370 Howarth Road
Media, PA 19063
February 1, 2016

Mr. John Hohenstein, P.E.
Chief, Dams and Waterways Section
Waterways and Wetlands
DEP Southeast Regional Office

Thank you for taking the time to discuss my concerns about the Sunoco Logistics plan for the installation of the Mariner East 2 pipeline on my property as evidenced by sheet ES-6.22 of the DELCO Conservation District ESC & Site Restoration Plan. I brought to your attention that the proposal was to use HDD under the stream and under Mt. Alverno Road as Sunoco personnel have informed me on their site visits. On close examination of the actual Tetra Tech print it appears that only the roadway will be bored, however.

EXHIBIT B MIDDLETOWN TOWNSHIP DELAWARE COUNTY, PENNSYLVANIA

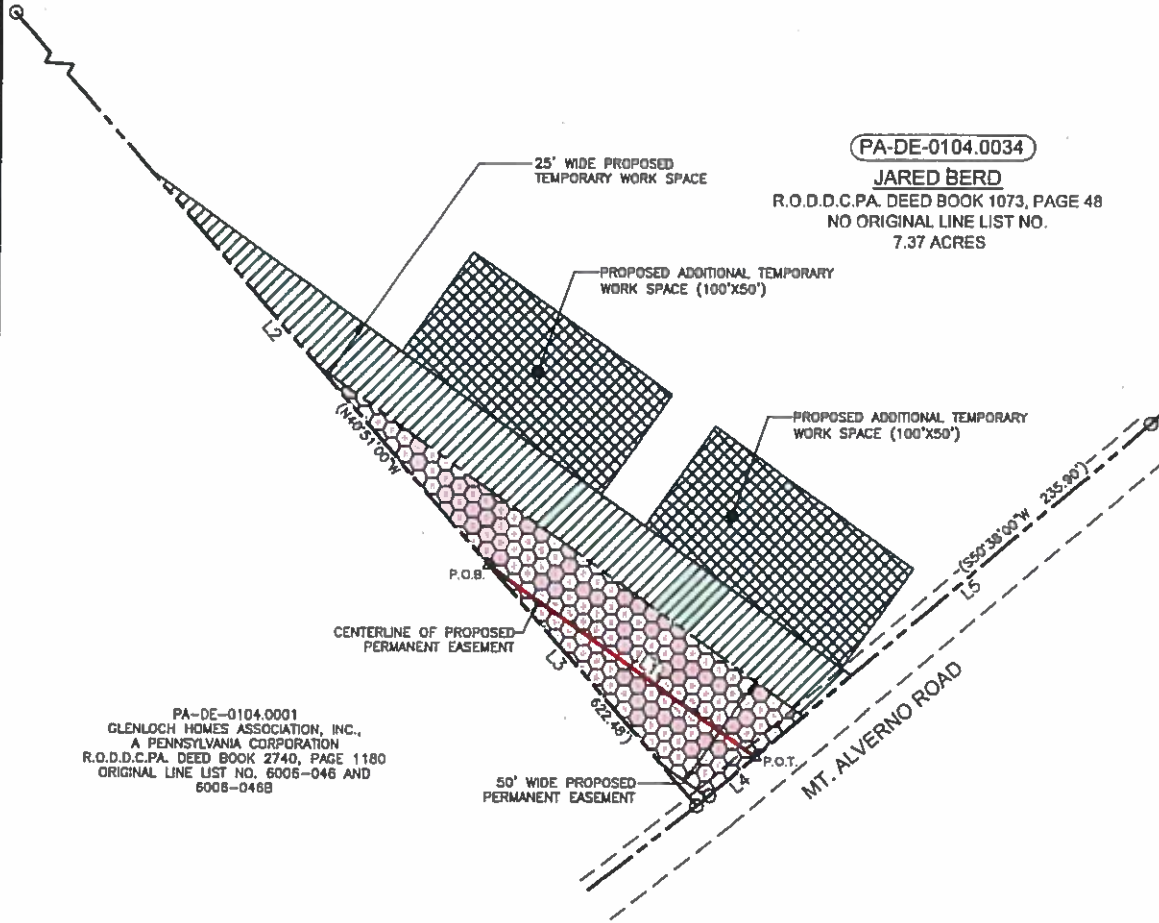
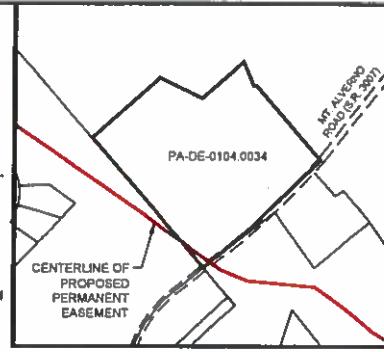
From my perspective it does not matter if both the stream and the road or just the road will be subject to HDD. The Right of Way Department of Sunoco Pipeline L.P. will not compromise on the need to both acquire and clear cut the two large (relative to my property) 'extra temporary workspaces' in the riparian buffer. The ostensible reason being to prepare the area for the HDD process. The Tetra Tech blueprint notwithstanding, Matthew Gordon told me that the plan was to use HDD under the stream and the road. More importantly, he said that HDD was not the preferred method here, that they would rather use conventional methods. Apparently it is another engineering company that selected the installation method based on the assumption that it would be required.

To clear cut the riparian buffer, especially on the steeply sloped east side of the stream is not acceptable to me. Nor does it appear to be acceptable according to the Bureau of Watershed Management's document "Riparian Forest Buffer Guidance" or according to the guidelines put forth in the "Governor's Pipeline Infrastructure Task Force Report".

If the requirement (perceived or actual) to use HDD could be removed the extra temporary work spaces that include the vital riparian buffers on both sides of the stream would not be needed. The project's environmental impact would be reduced to the minimum. Conventional techniques were used when Atlantic replaced the adjacent Mariner East 1 pipe in the early 1990's and it was a non event.
